### **Remarks**

**Corrections to the Drawings**

**Version with markings to show amendments made:**

**FIG. 1**

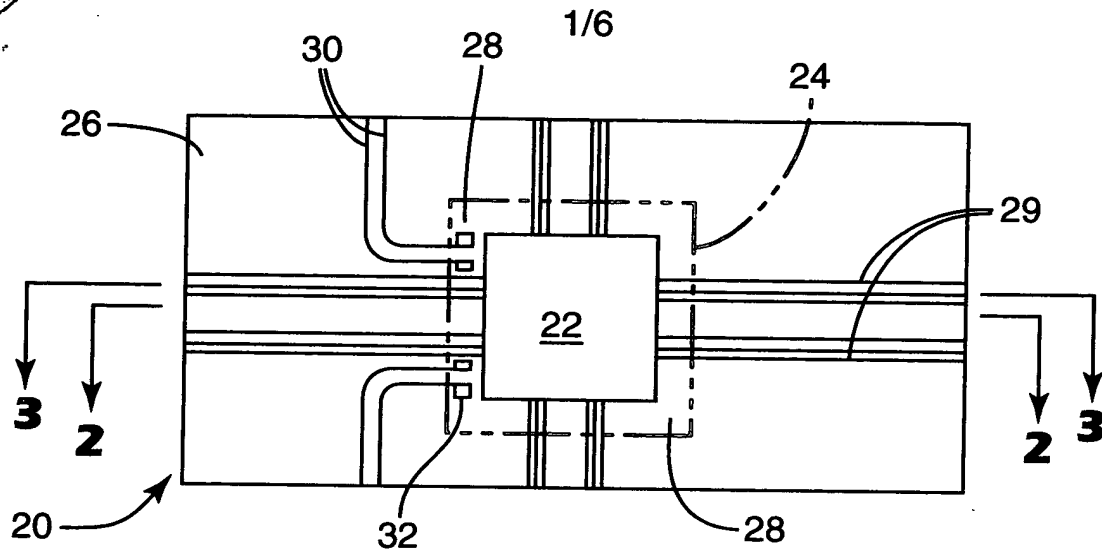
**Figure 1** has been amended as follows:

The line format of the die (**24**) has been changed to “phantom.” Support for this amendment is found on page 7, lines 6-7.

**FIG. 2**

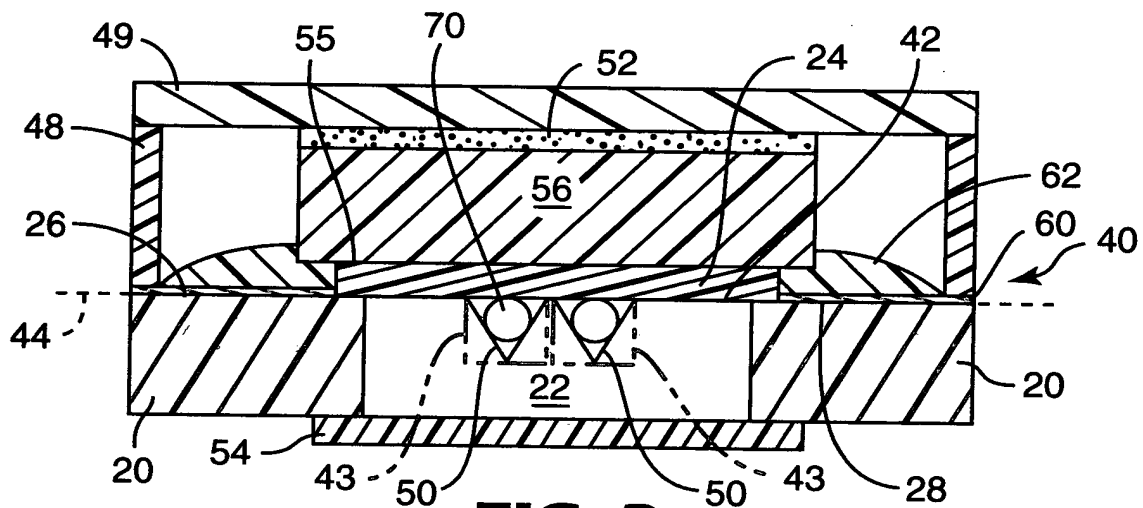
**Figure 2** has been amended as follows:

The cross-hatching of the package frame (**20**) has been changed to indicate an insulative part. Support for this amendment is found at page 7, line 24 - page 8, line 12.

The cross-hatching has been removed from the aperture (**22**). Support for this amendment is found at page 10, lines 20-25.

The line format for optical micro-mechanical devices (**43**) has been changed to “phantom.” Support for this amendment is found at page 8, lines 20-21.

The cross-hatching for the flex circuit (**60**) has been changed to indicate a conductive material. Support for this amendment is found at page 9, lines 15-21.

The cross-hatching has been removed from the lenses (**70**) shown in end-view. Support for this amendment is found at page 2, lines 27-31.

**FIG. 3**

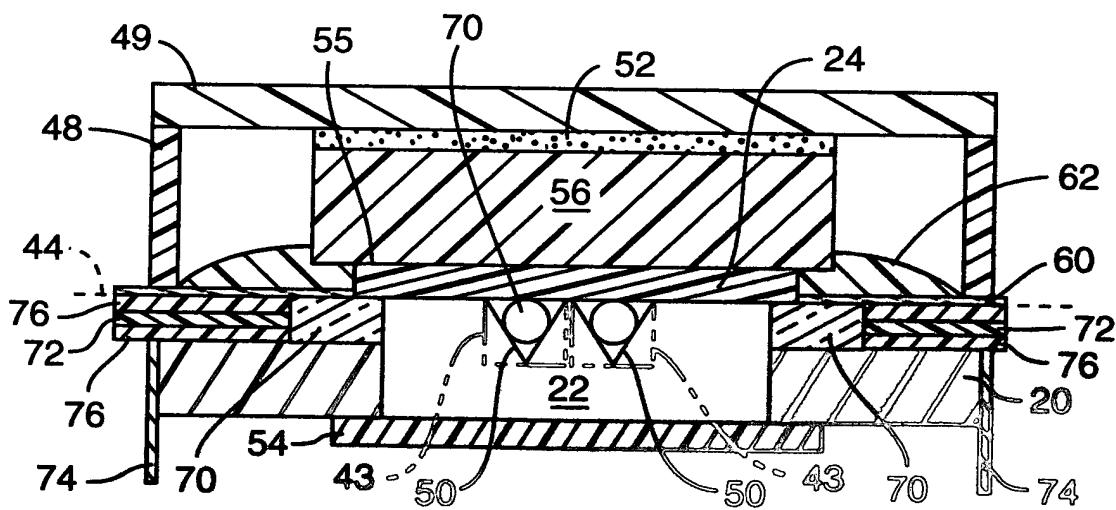
**Figure 3** has been amended as follows:

The cross-hatching of the package frame (**20**) has been changed to indicate an insulative part. Support for this amendment is found at page 7, line 24 - page 8, line 12.

The cross-hatching has been removed from the aperture (**22**). Support for this amendment is found at page 10, lines 20-25.

The line format for optical micro-mechanical devices (**43**) has been changed to “phantom.” Support for this amendment is found at page 8, lines 20-21.

The cross-hatching for the flex circuit (**60**) has been changed to indicate a conductive material. Support for this amendment is found at page 9, lines 15-21.

The cross-hatching has been removed from the lenses (70) shown in end-view. Support for this amendment is found at page 2, lines 27-31.

**FIG. 4**

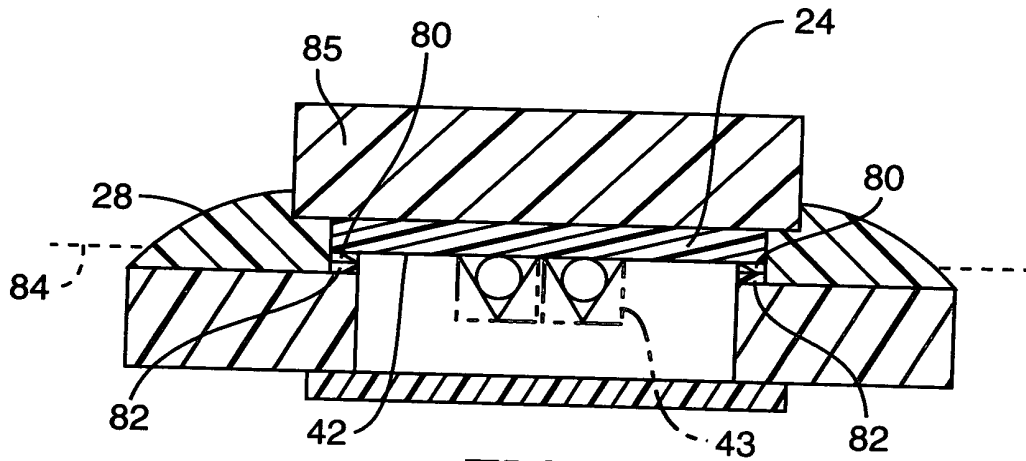
**Figure 4** has been amended as follows:

The cross-hatching of the package frame has been changed to indicate an insulative part. Support for this amendment is found at page 7, line 24 - page 8, line 12.

The cross-hatching has been removed from the aperture. Support for this amendment is found at page 10, lines 20-25.

The line format for optical micro-mechanical devices (43) has been changed to "phantom." Support for this amendment is found at page 8, lines 20-21.

The cross-hatching has been removed from the lenses shown in end-view. Support for this amendment is found at page 2, lines 27-31.

**FIG. 5**

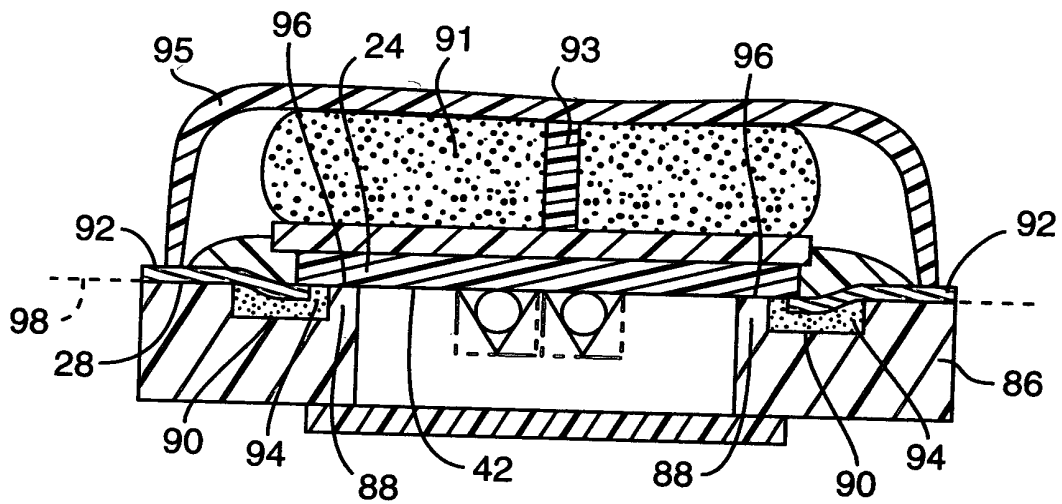
**Figure 5** has been amended as follows:

The cross-hatching of the package frame (86) has been changed to indicate an insulative part. Support for this amendment is found at page 7, line 24 - page 8, line 12.

The cross-hatching has been removed from the aperture. Support for this amendment is found at page 10, lines 20-25.

The line format for optical micro-mechanical devices has been changed to "phantom." Support for this amendment is found at page 8, lines 20-21.

The cross-hatching for the flex circuit (92) has been changed to indicate a conductive material. Support for this amendment is found at page 11, lines 30-32.

The cross-hatching has been removed from the lenses shown in end-view. Support for this amendment is found at page 2, lines 27-31.

**FIG. 10**

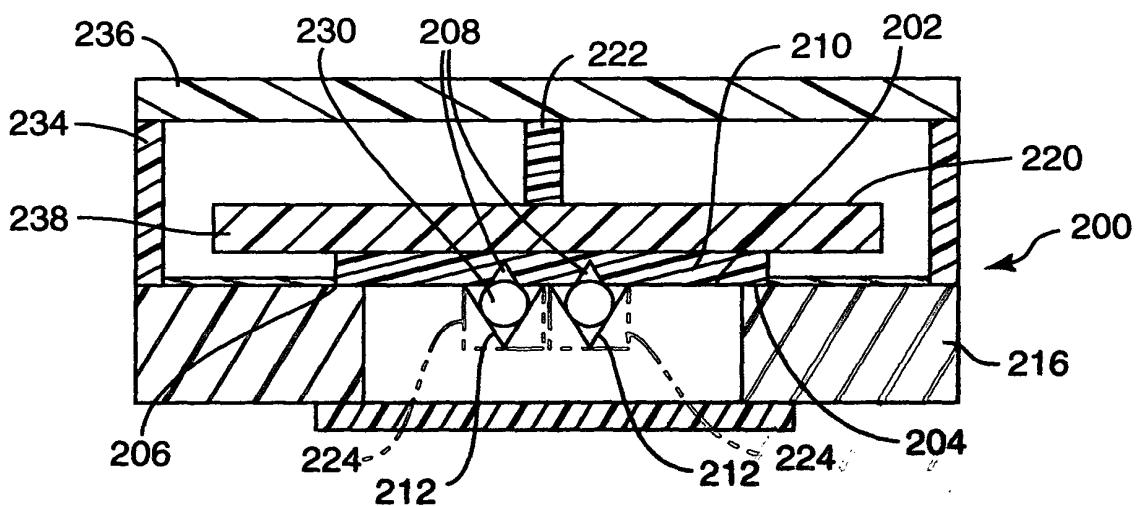
**Figure 10** has been amended as follows:

The cross-hatching of the package frame (**216**) has been changed to indicate an insulative part. Support for this amendment is found at page 7, line 24 - page 8, line 12.

The cross-hatching has been removed from the aperture. Support for this amendment is found at page 10, lines 20-25.

The cross-hatching for the flex circuit has been changed to indicate a conductive material. Support for this amendment is found at, e.g., page 14, lines 1-3.

The line format for optical micro-mechanical devices (**224**) has been changed to "phantom." Support for this amendment is found at page 8, lines 20-21.

The cross-hatching has been removed from the lenses (**230**) shown in end-view. Support for this amendment is found at page 2, lines 27-31.

**FIG. 12**

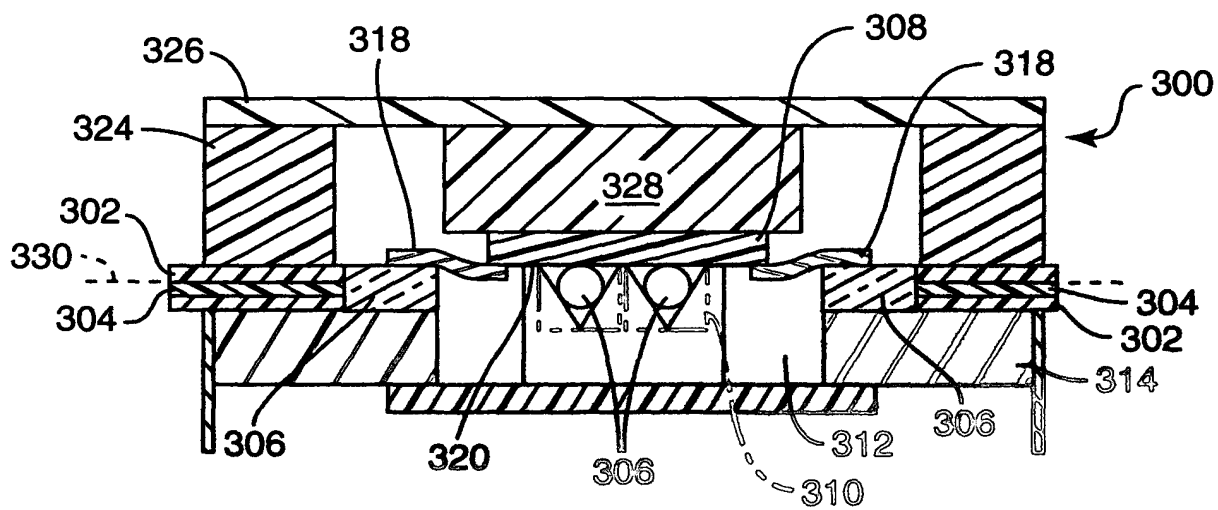
**Figure 12** has been amended as follows:

The cross-hatching of the package frame (314) has been changed to indicate an insulative part. Support for this amendment is found at page 7, line 24 - page 8, line 12.

The cross-hatching has been removed from the aperture (312). Support for this amendment is found at page 10, lines 20-25.

The line format for optical micro-mechanical devices (310) has been changed to "phantom." Support for this amendment is found at page 8, lines 20-21.

The cross-hatching for the flex circuit (318) has been changed to indicate a conductive material. Support for this amendment is found at page 15, lines 15-18.

The cross-hatching has been removed from the lenses (306) shown in end-view. Support for this amendment is found at page 2, lines 27-31.
